TECHNICAL BULLETIN

MODEL/DERIVATIVE:
Mini

No: **014**
Ref: **R0962bu**
Issue: **1**
Date: **30.10.96**

PROBLEM:
ENGINE NON START / FUEL PUMP NOISE - PIPE DAMAGE

A0962ED1

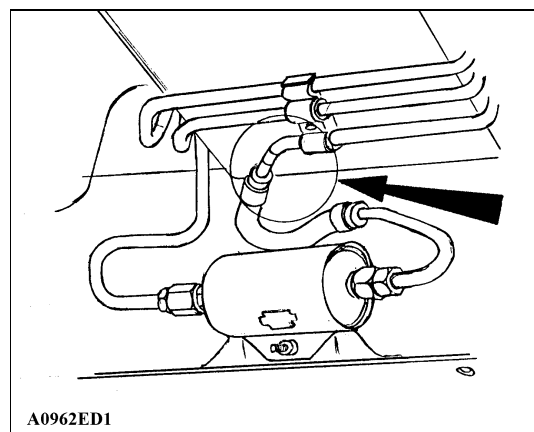
Either of the following:-
Engine non-start or difficult to start.
Excessive noise from fuel pump.

CAUSE:
Bent under floor fuel feed pipe particularly in area illustrated. This may result in the flexible fuel feed hose being kinked causing local fuel pressure build-up.

ACTION:
Carefully re-shape fuel feed pipe so that flexible hose returns to correct position.
